SUBJECT: Withdraw of the November 16, 2015 Application for Modification, AND Application for Modification with Additional Information for Section 404 Individual Permit and Section 401 Individual Water Quality Certification for the US-74 Monroe Connector/Bypass in Union and Mecklenburg Counties. STIP R-3329 and STIP R-2559, Division 10, Debit WBS Element 34533.1.TA1 in the amount of \$570.

Reference: US Army Corps of Engineers (USACE) 404 Permit issued May 8, 2015; Action ID: SAW-2009-00876
NC Division of Water Resources (NCDWR) 401 Water Quality Certification Permit issued March 6, 2015; NCDWR Project No. 02-0672 V3

The North Carolina Department of Transportation (NCDOT) is in the process of constructing the Monroe Connector/Bypass, as authorized by the USACE and NCDWR as referenced above. NCDOT is requesting a permit modification for ten Permit Sites: 3, 5, 29, 30, 37, 46, 47, 48, 54, and 57, which are detailed below. Two other sites, 6 and 60, have revisions in jurisdictional areas that do not require a permit modification (see below).

Permit Site 5 (Revised Permit Drawings 27 and 28 of 267):

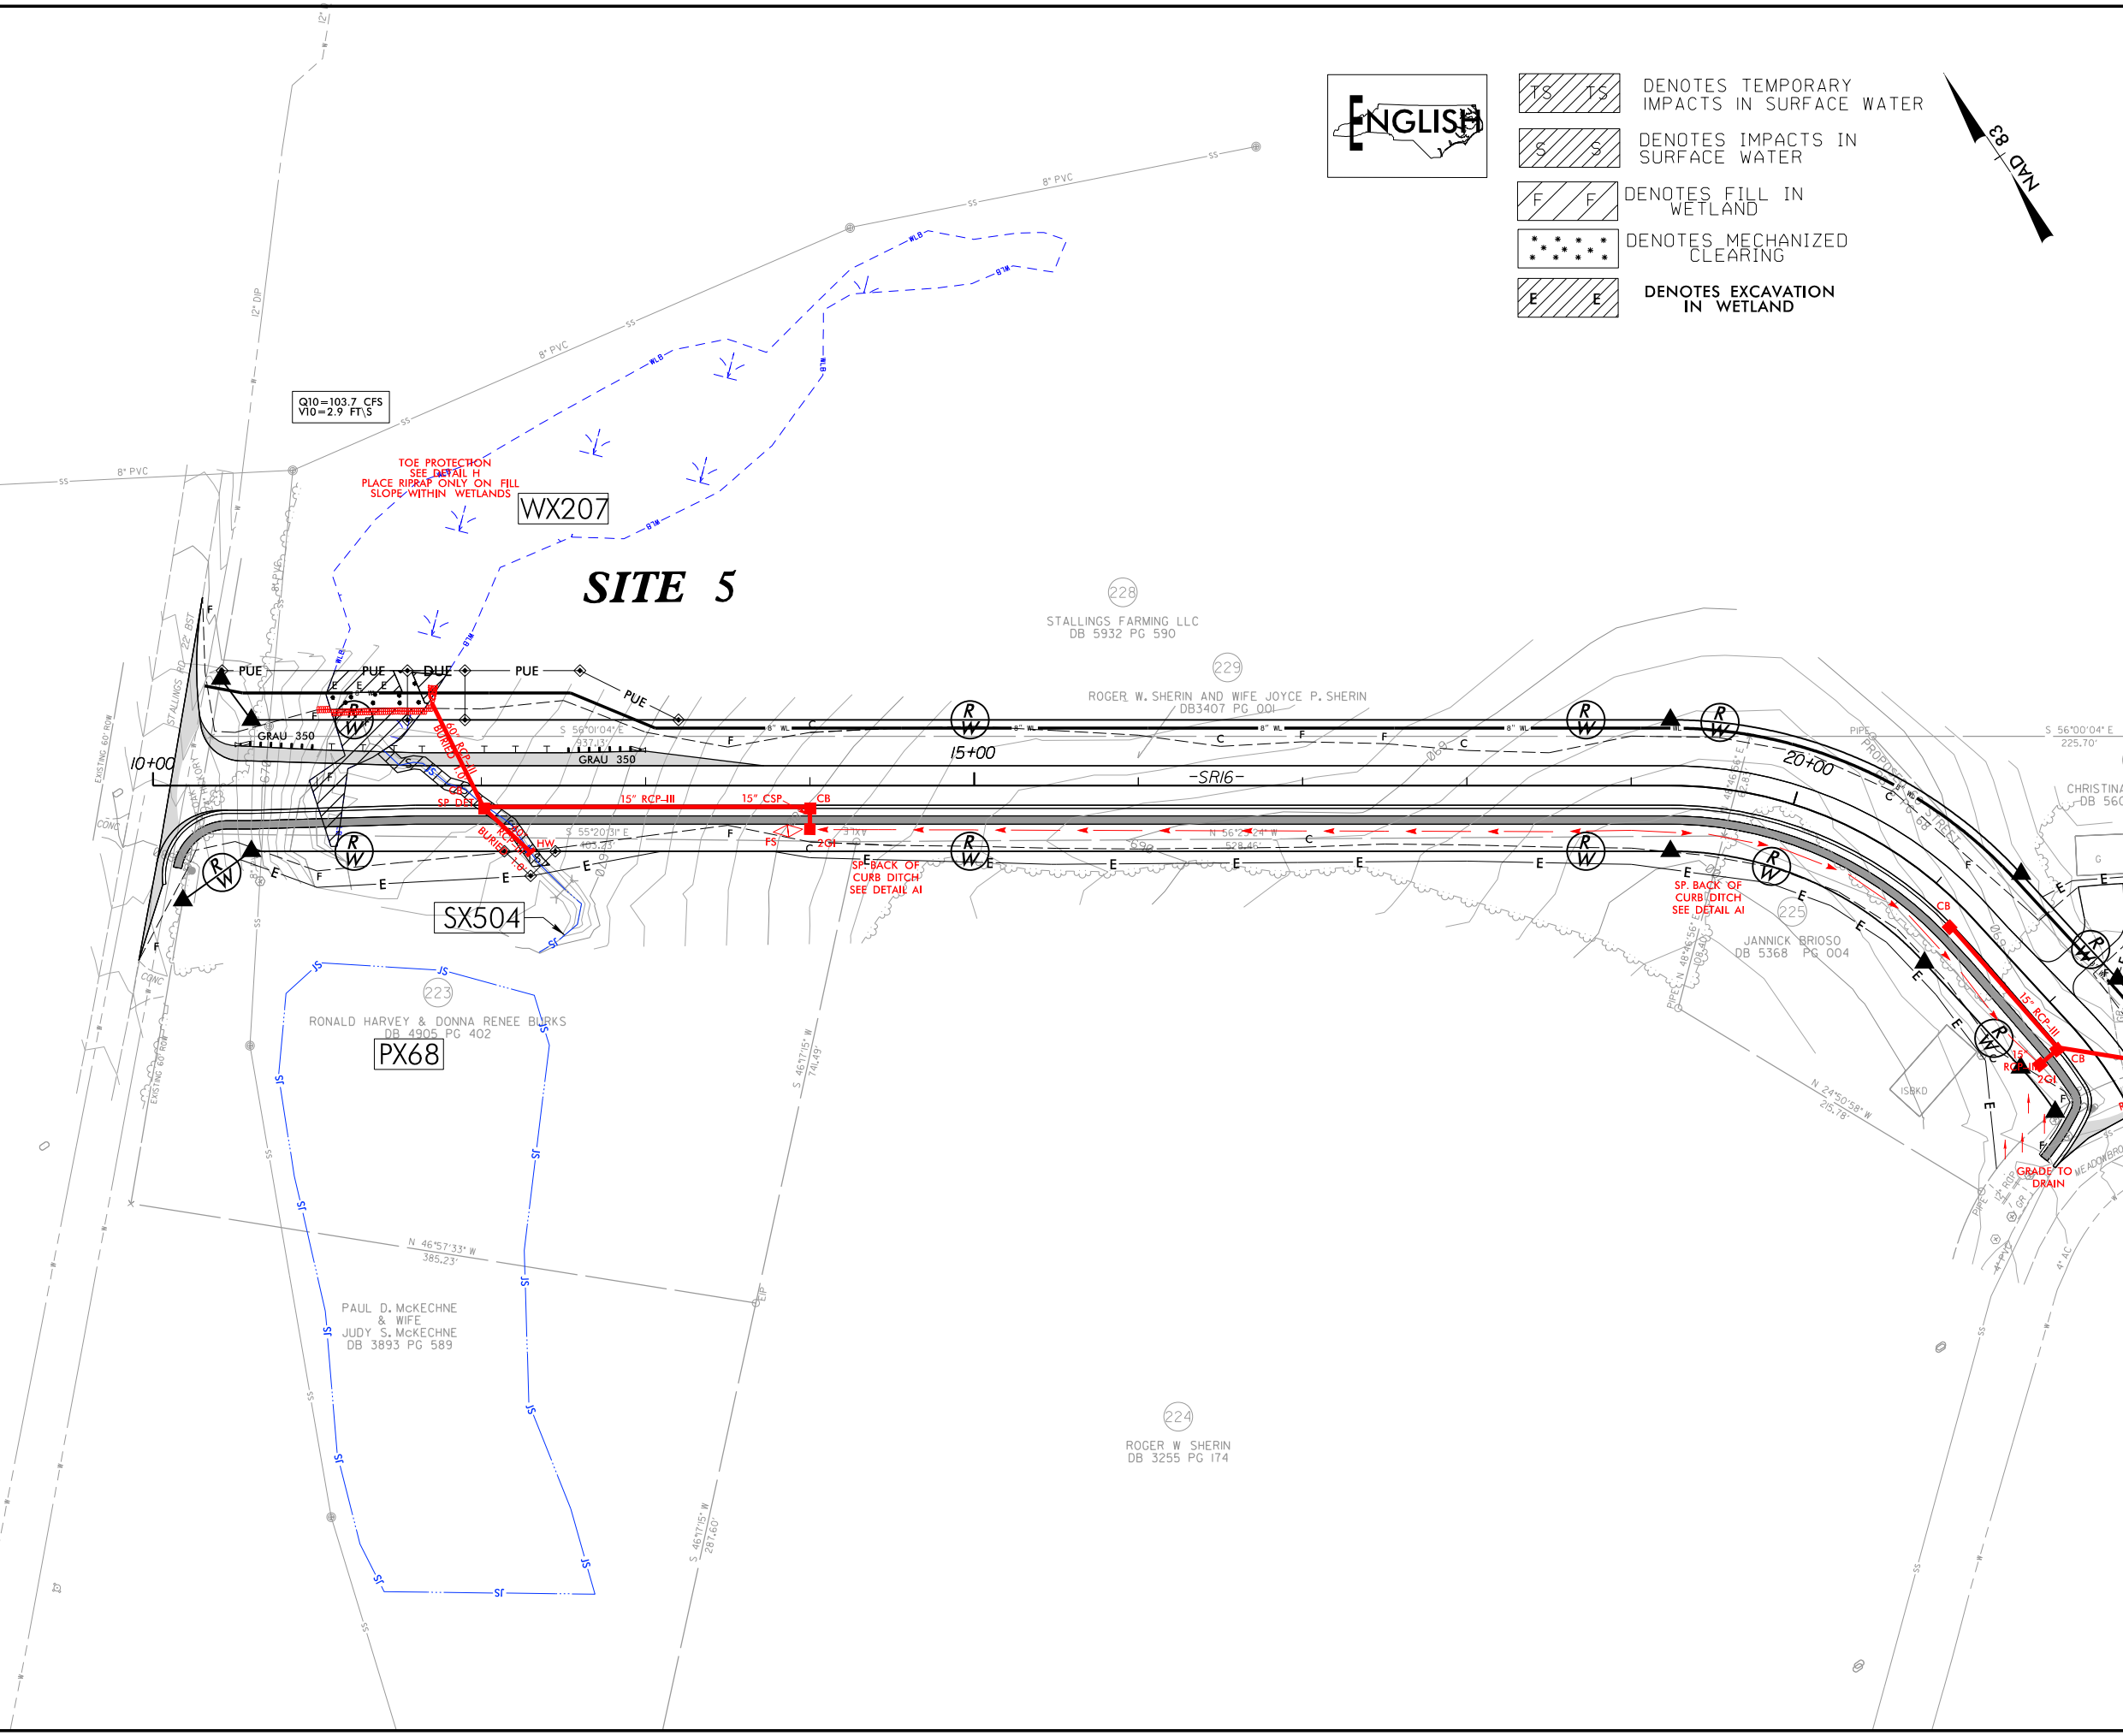
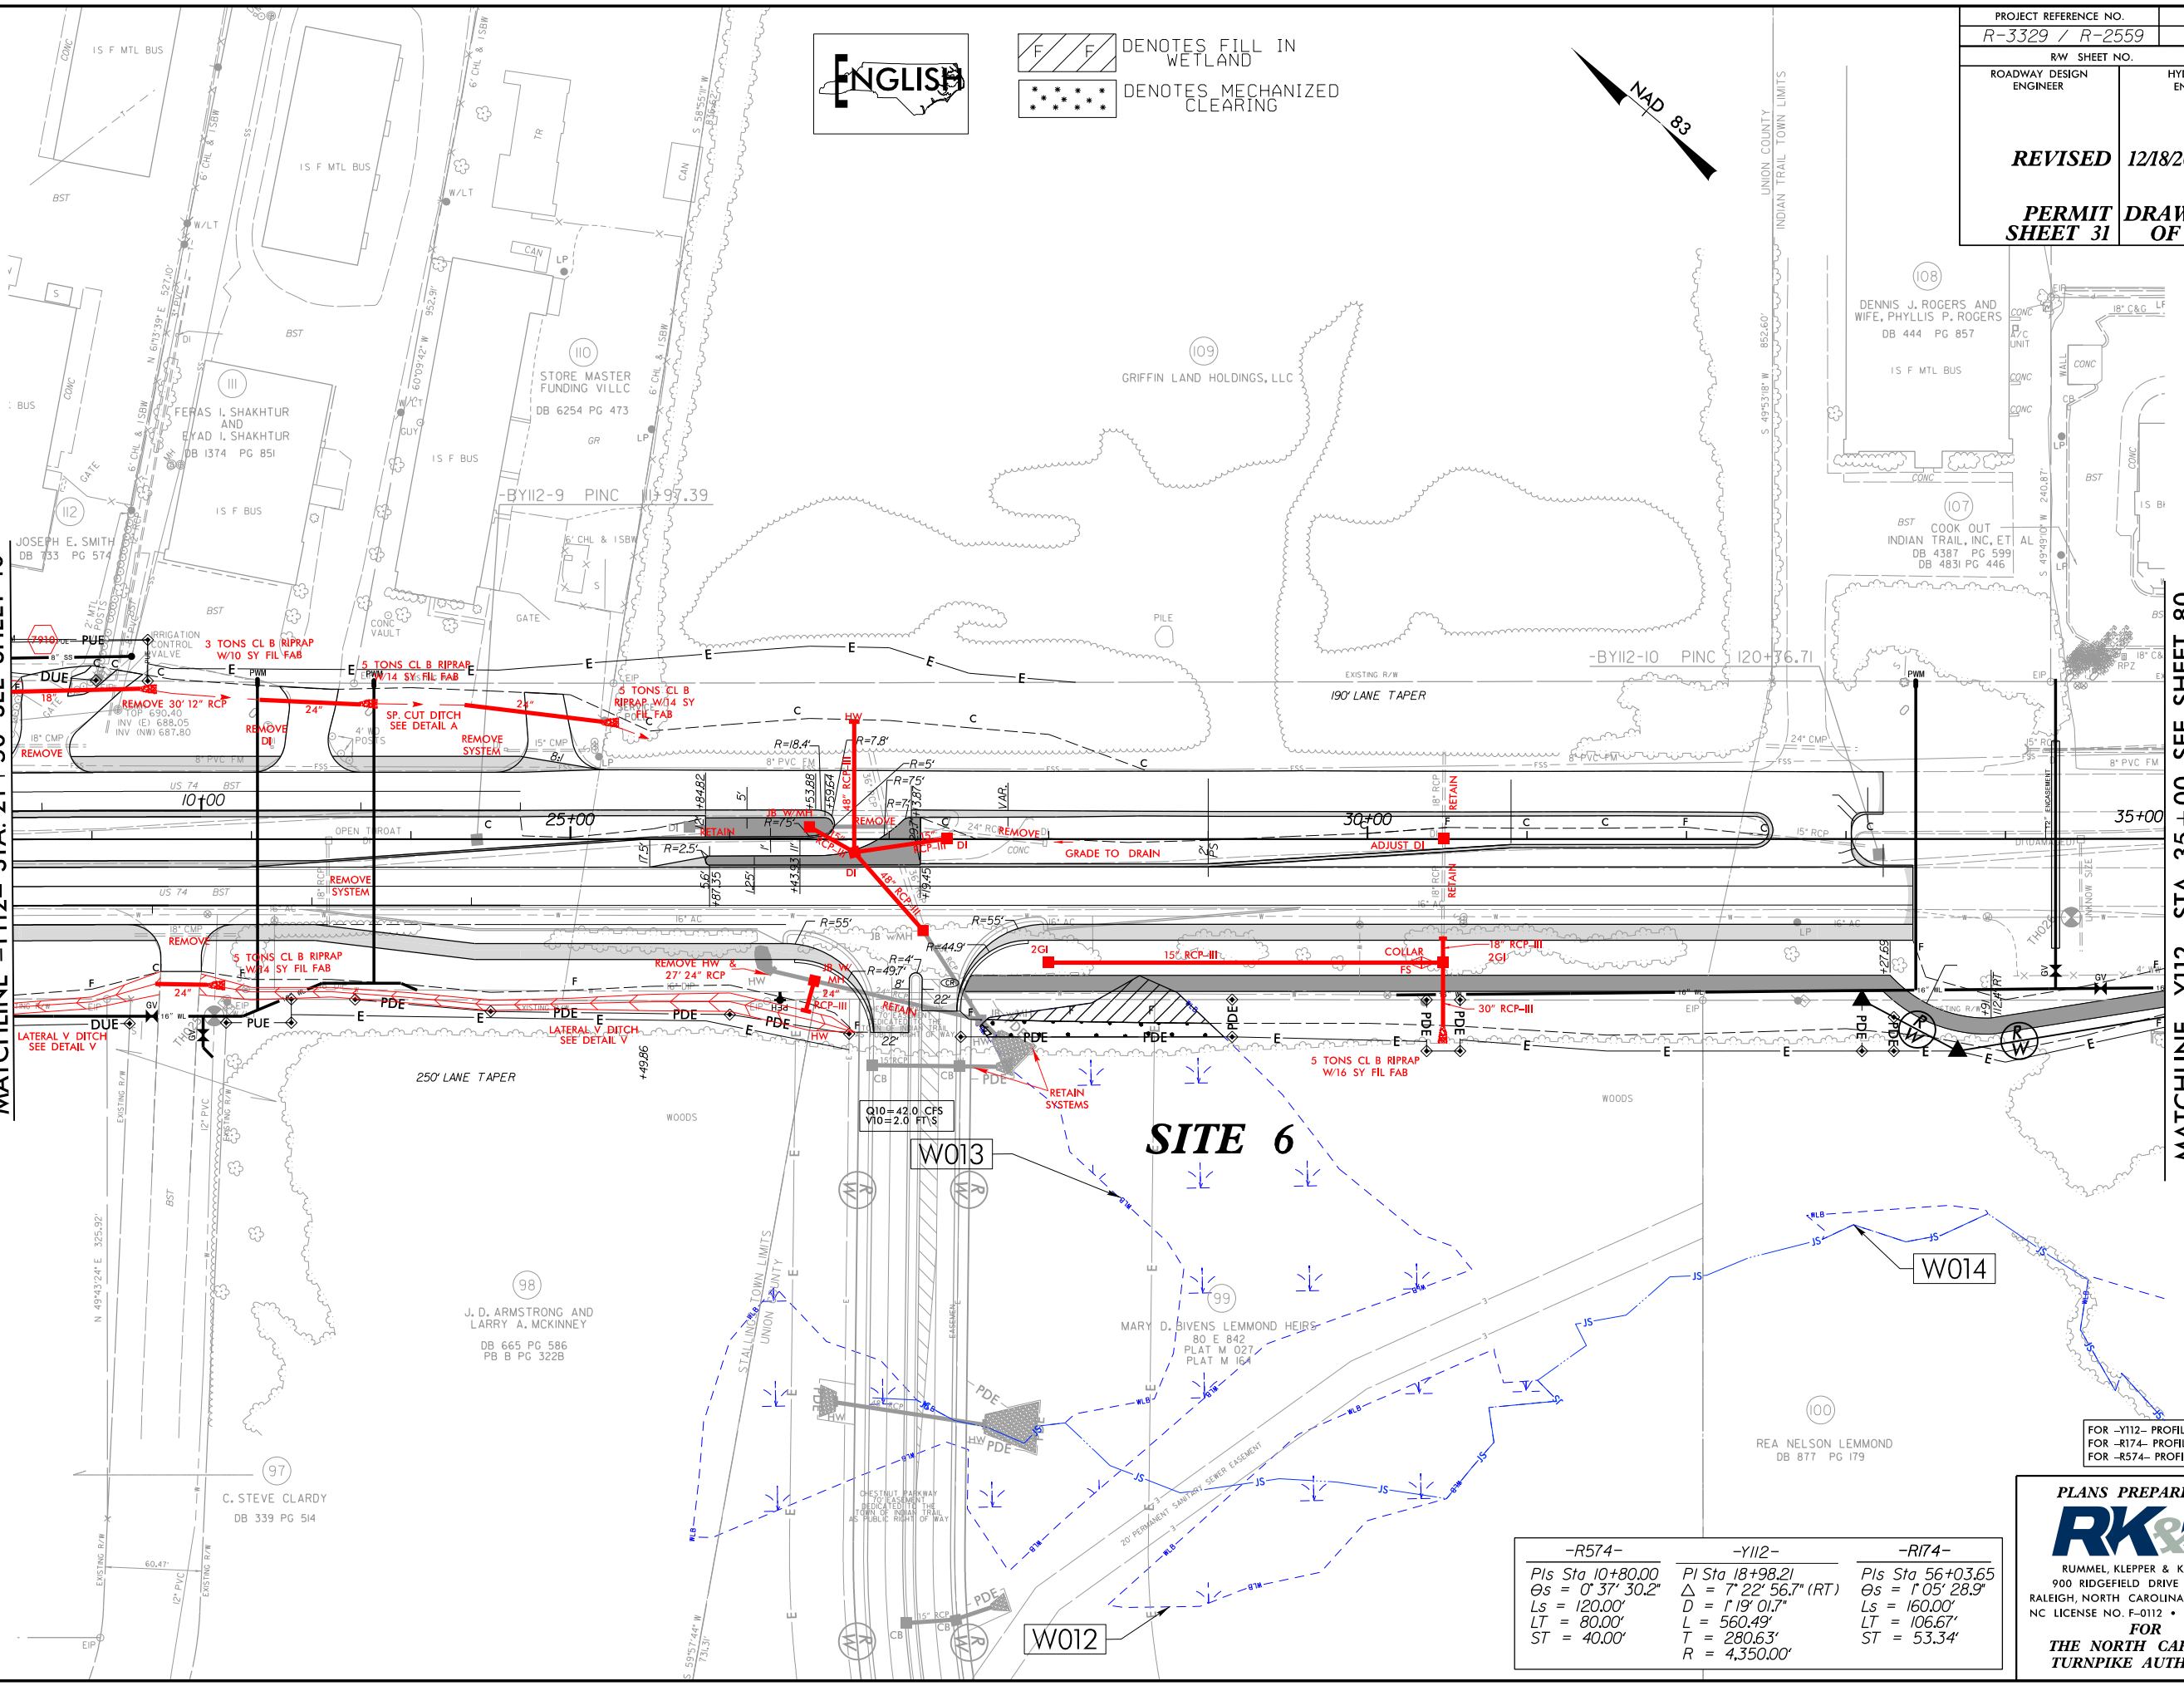
In addition to the previously permitted 0.05 acre of wetland fill, 0.02 acre of mechanized clearing, 114 lf of permanent stream impacts, and 12 lf of temporary stream impacts, the installation of a water line will result in the **temporary excavation of 0.01 acre in wetland WX207.**
